SERVICE BULLETIN

SUBJECT TS-930S ALC LEVEL DRIFT 28 MHZ CW

DATE 8-25-83

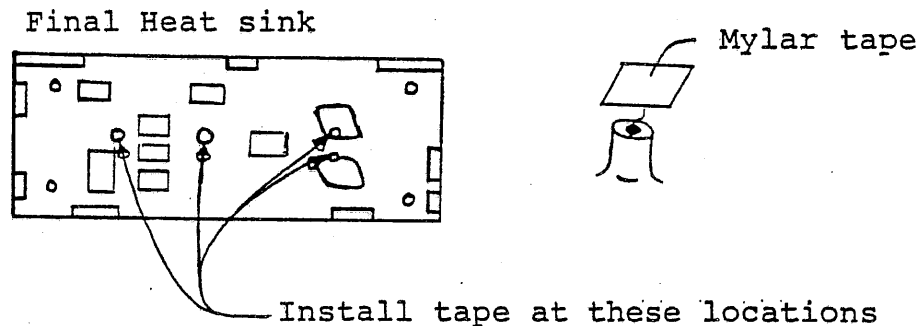
Some users have reported that the ALC meter indication occasionally jumps during long key down periods on the 28 Mhz portion of the bands. The symptom may be caused by the ground foil of the Final Unit (X56-1430-00) coming in contact with one or more of the projections on the final heat sink, due to expansion when the temperature rises.

Apply mylar insulating tape to the projections on the heat sink, to prevent reoccurrence of this symptom. See figures below.
